**Genoa Charter Township Election Commission
Special Meeting
Sept. 3, 2013
6:25 p.m.**

**GENOA CHARTER TOWNSHIP BOARD
Regular Meeting
September 3, 2013
6:30 p.m.**

RE: Michigan Rod Products- Special Land Use & Site Plan Approval

Attention:	Kelly Van Marter, AICP Assistant Township Manager and Planning Director
Subject:	Michigan Rod Products – Special Land Use and Site Plan Review #2
Location:	1326 Grand Oaks Drive – west side of Grand Oaks, south of Cleary Drive
Zoning:	IND Industrial District

Enlarged Grading Plan

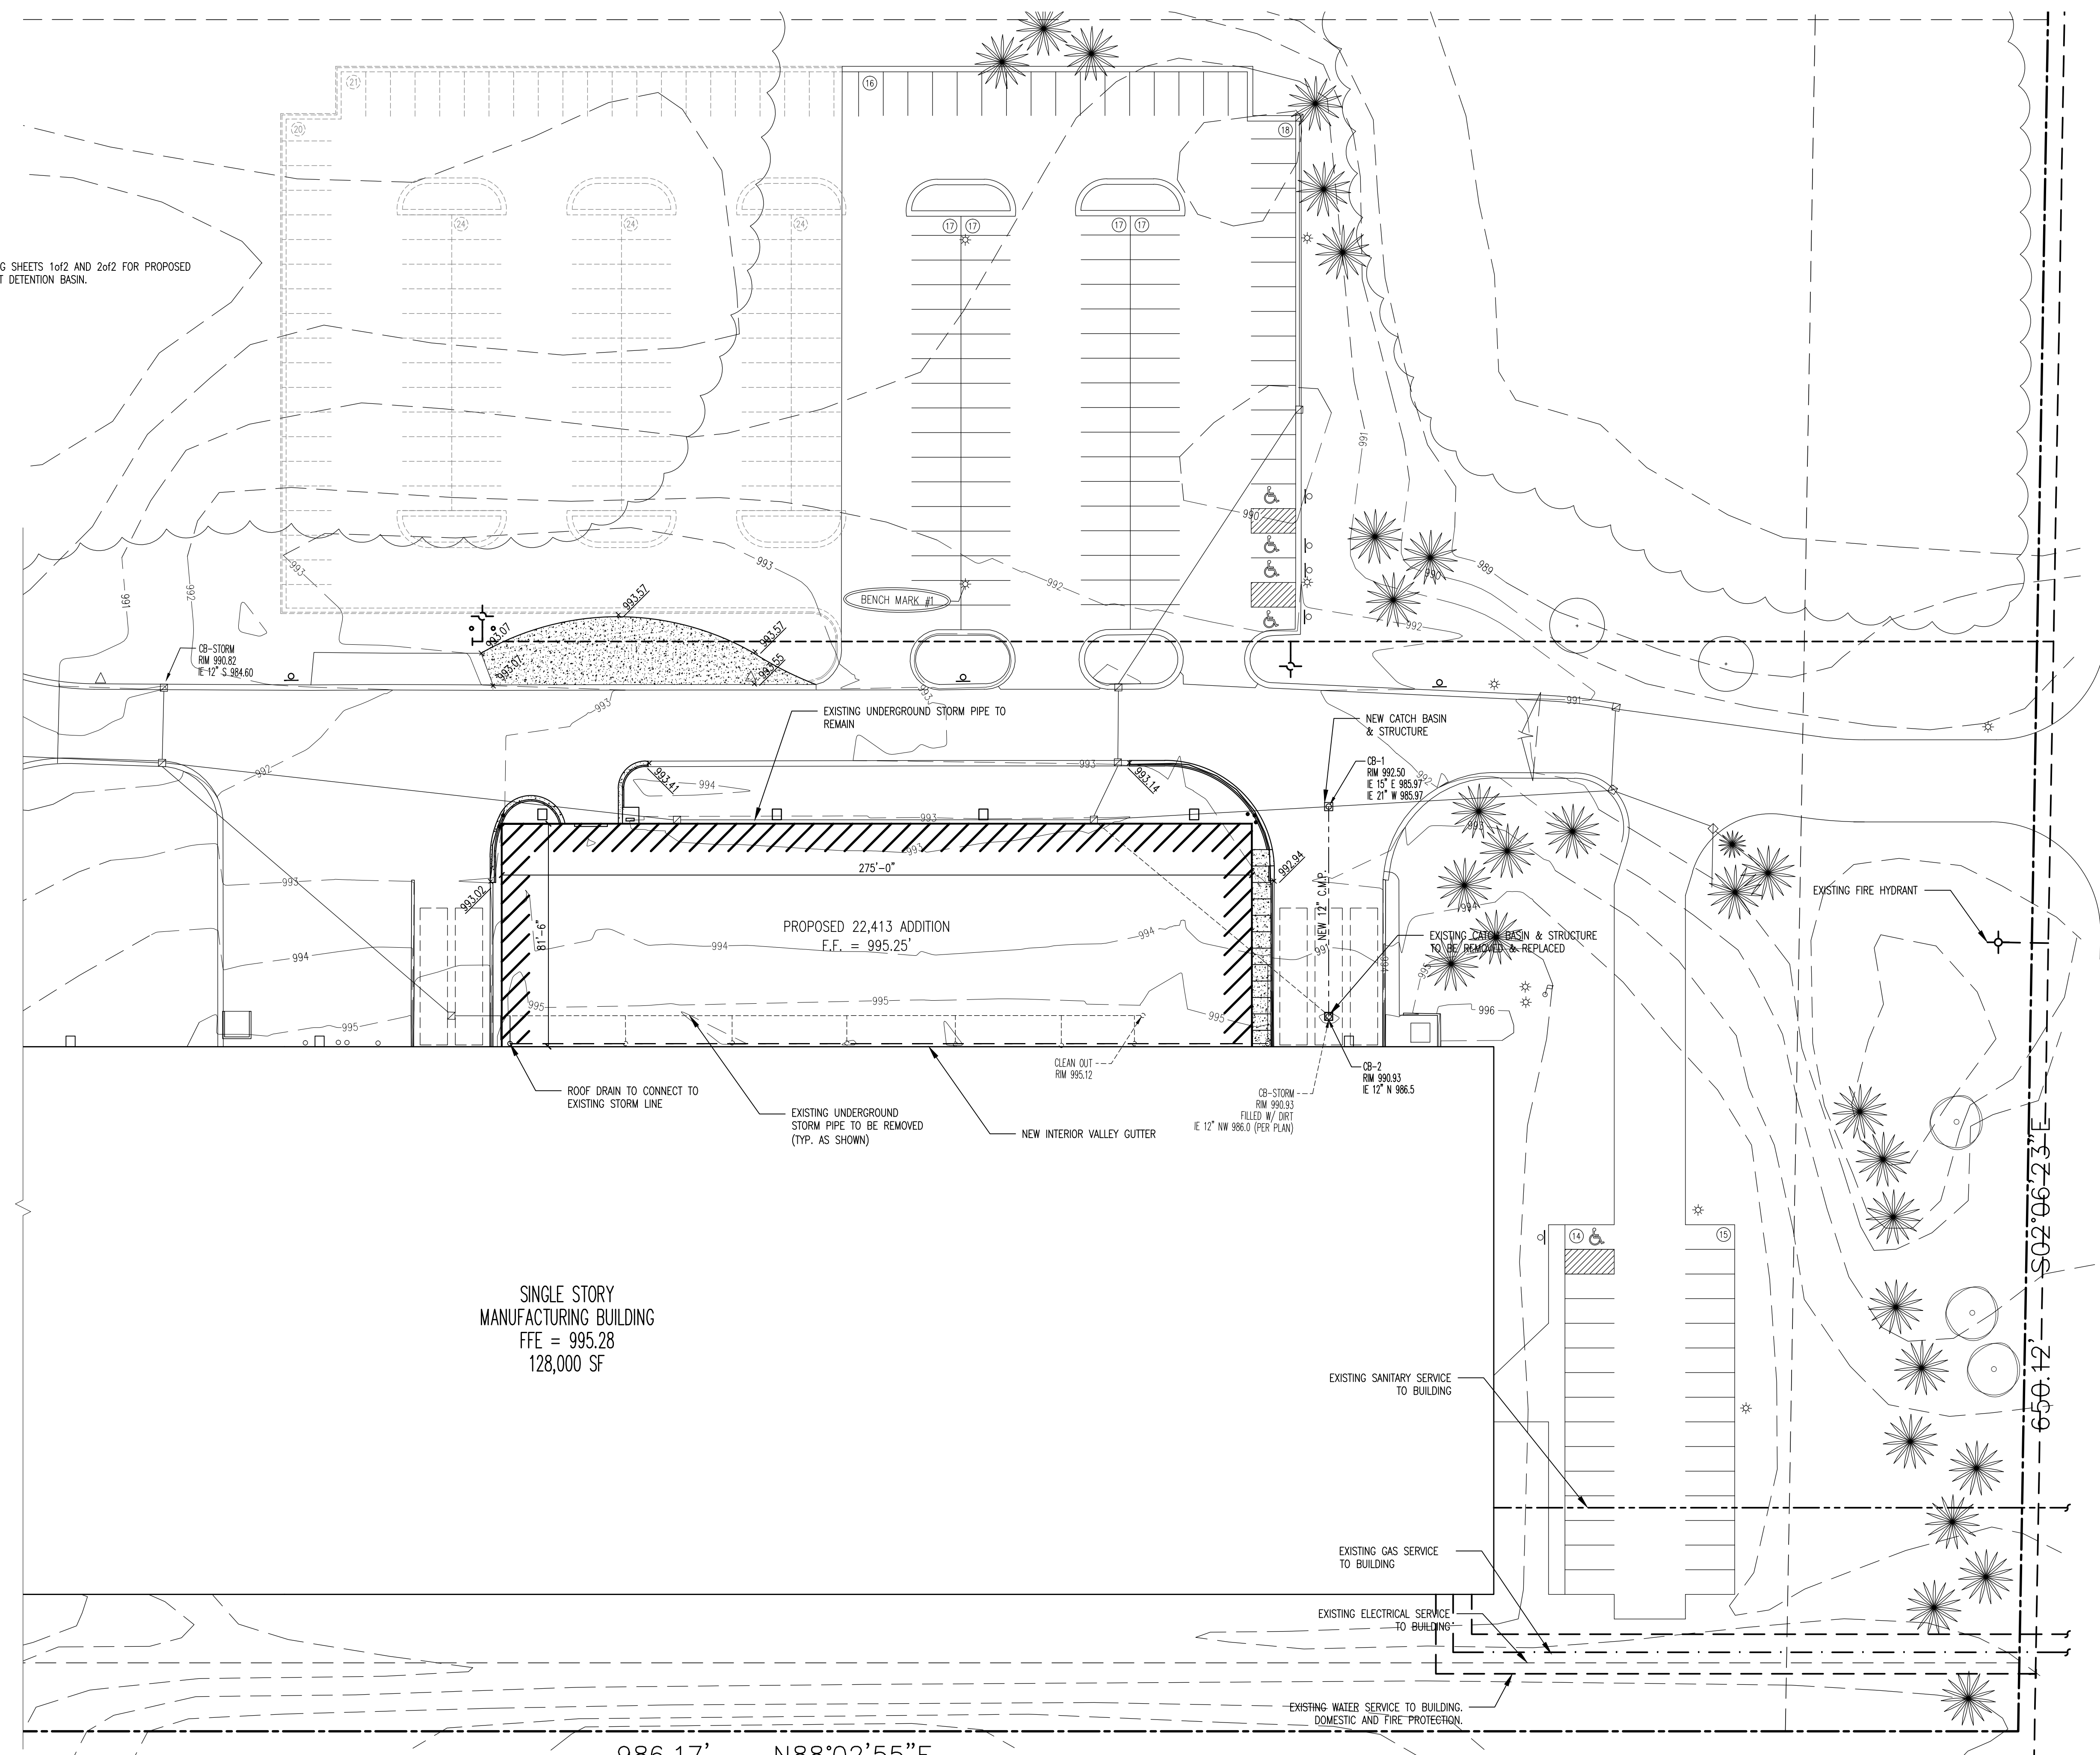
- 4. Vehicular Circulation.** The proposed site plan will not substantially alter existing circulation patterns. As requested in our initial review letter, the applicant has provided a truck turning template to Sheet C1.3 and has added a small paved area as a potential truck “run-off” space.

OUTLET CONTROL STRUCTURE DETAIL
NTS

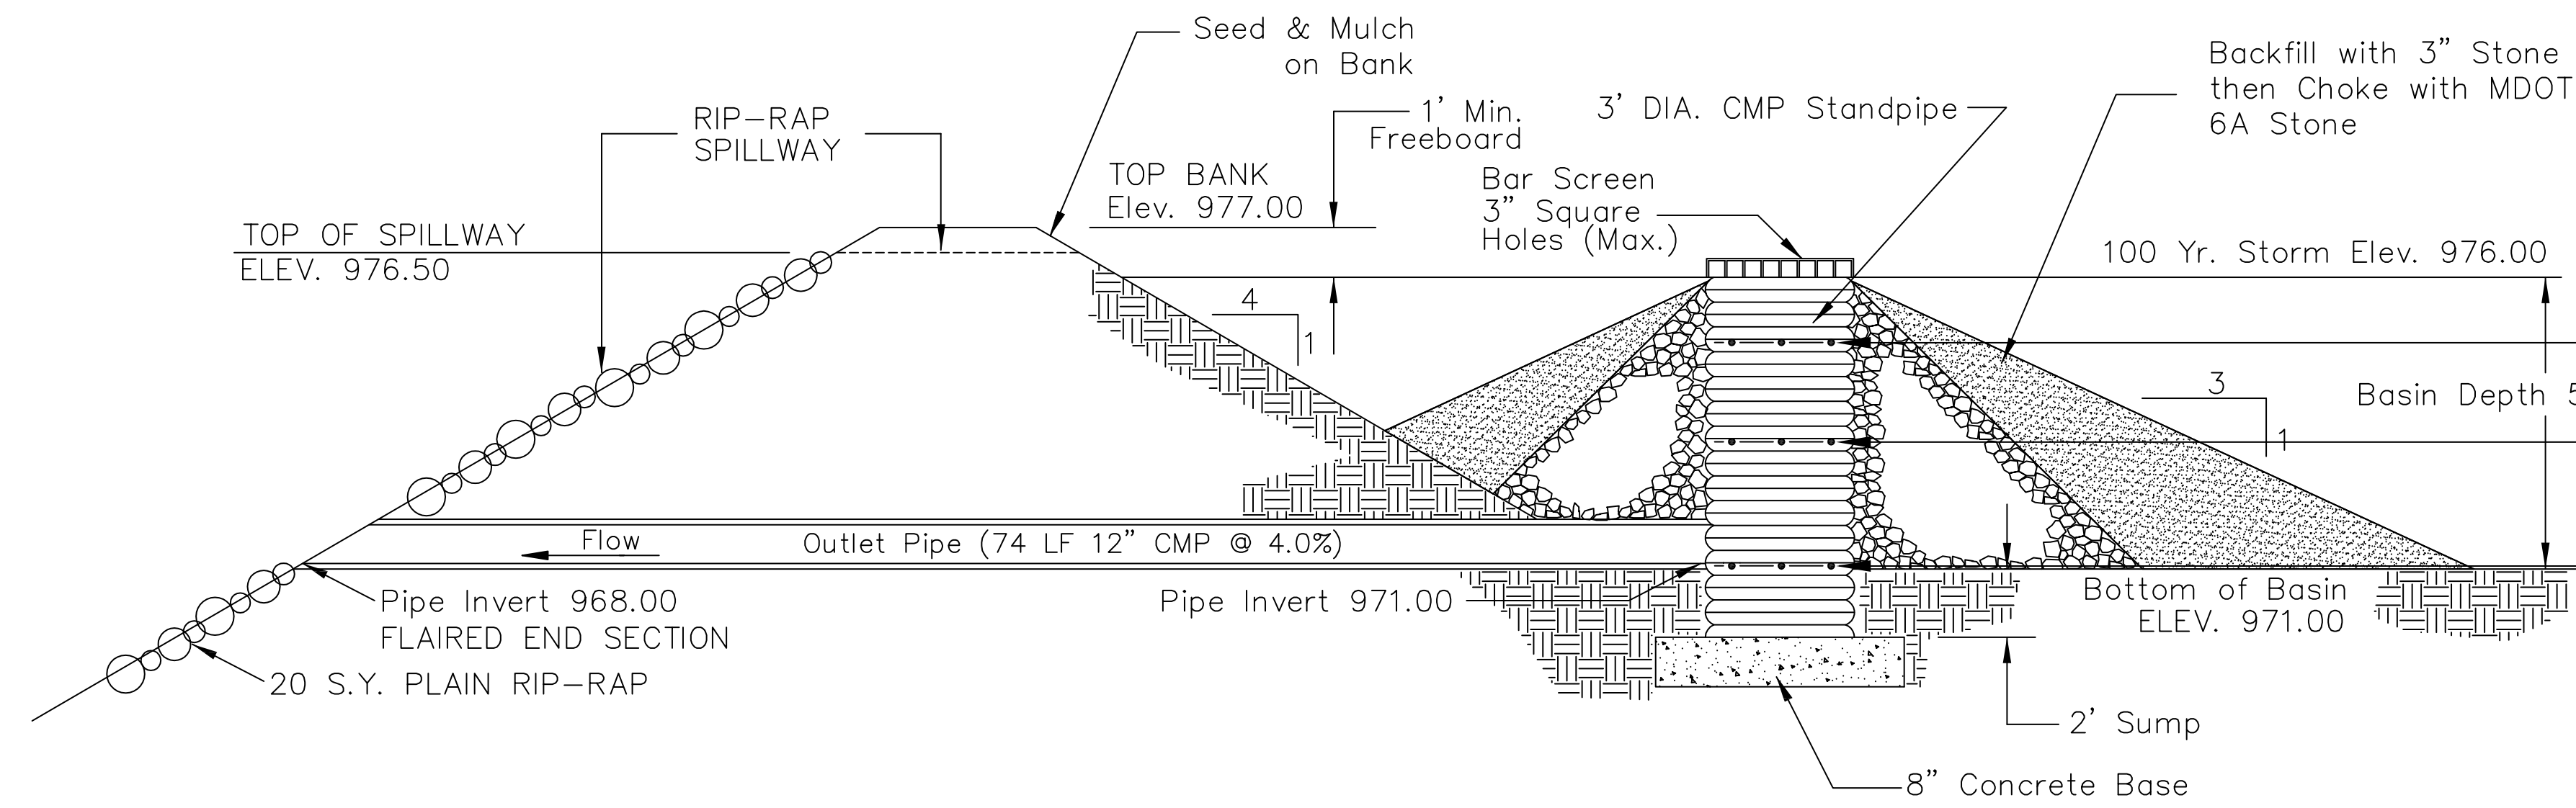
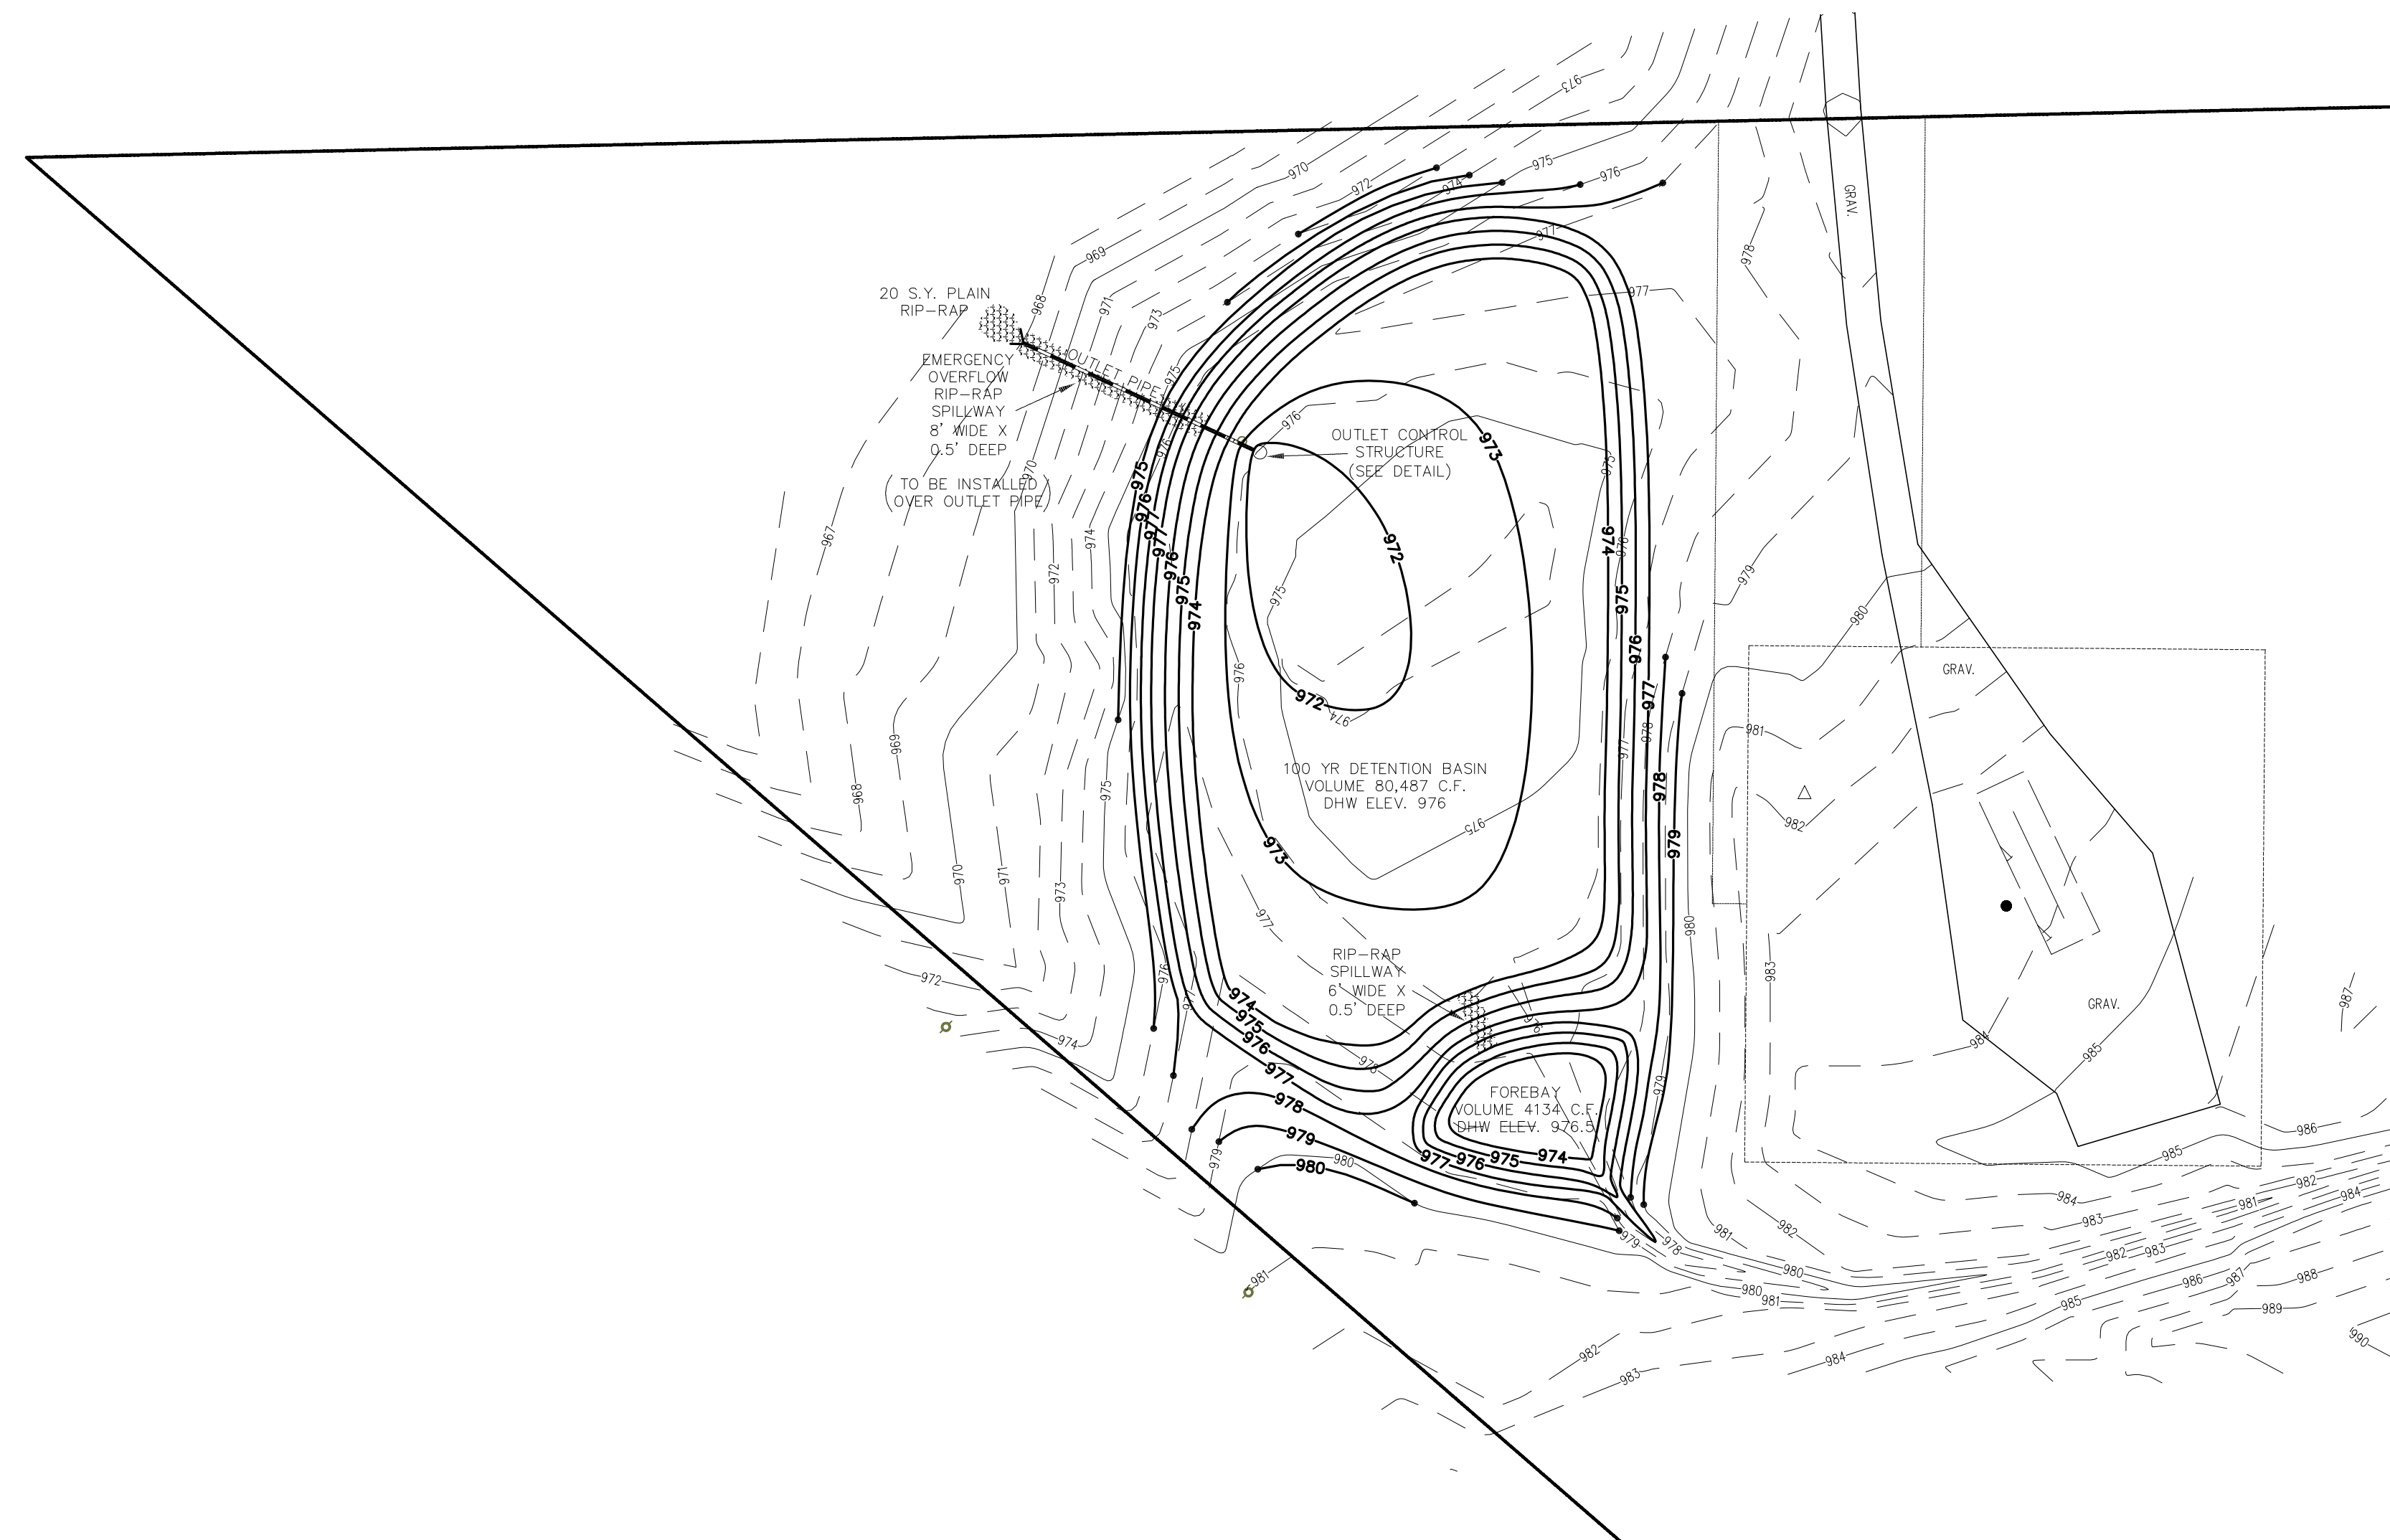
1. With the existing detention basin now shown on the plans, the proposed system has been reviewed and it does not appear to meet current Township standards. The impact statement notes there is a 74,326 cubic foot detention basin on site. Using the site information provided in your calculations, the basin is already under capacity and doesn't appear to have a sediment forebay to capture suspended particles from the first-flush. The table below shows the results of the site runoff for the pre- and post- construction modified C factor.

It is recommended to utilize the depressed area near the existing stormwater outfall as the location of the forebay and to construct a more defined swale to the detention basin around the existing gas well. Additional excavation in the channel and edge of basin can be performed to meet the new detention requirements. The petitioner has corrected all of the existing site information but must still provide solutions to the comments above and resubmit the site plan for review.

The detention basin will be modified to hold 80,487 cu ft with a Fore Bay with a capacity of 4,134 cu ft. See new engineering sheets included in revised drawing set.
